RE: DOE FEMP
COMMENTS: DMEPP
JANUARY-JUNE 1997

This letter provides Ohio Environmental comments on the South Plume Removal Action Design Monitoring Evaluation Program Plan system Evaluation Report for January 1-June 30, 1997.

Ohio Environmental Protection Agency comments on the DMEPP January-June 1997

Figure 1. Monthly average uranium concentrations and estimated daily recovery well pumping rates at RW-1 (3924), RW-2 (3925), RW-3 (3926), and RW-4 (3927).

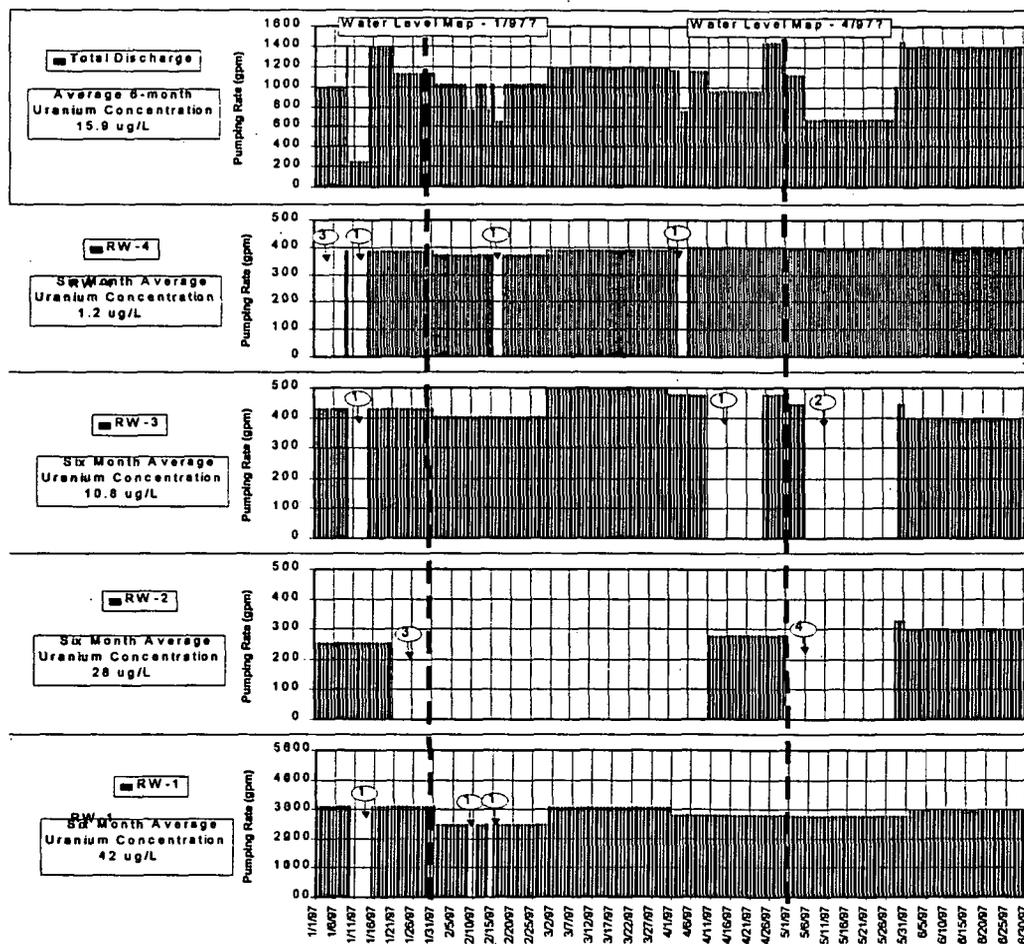
- 3) Commenting Organization: OEPA Commentor: HSI-GeoTrans, Inc.
 Section # :1.0 Operational Summary Pg. #: 1-2 Line # 16 Code: C
 Comment: The operational summary sheets for the four extraction wells provide flow rates on a only monthly basis. To help assess system performance more accurately, average daily flows should be summarized graphically in this report.
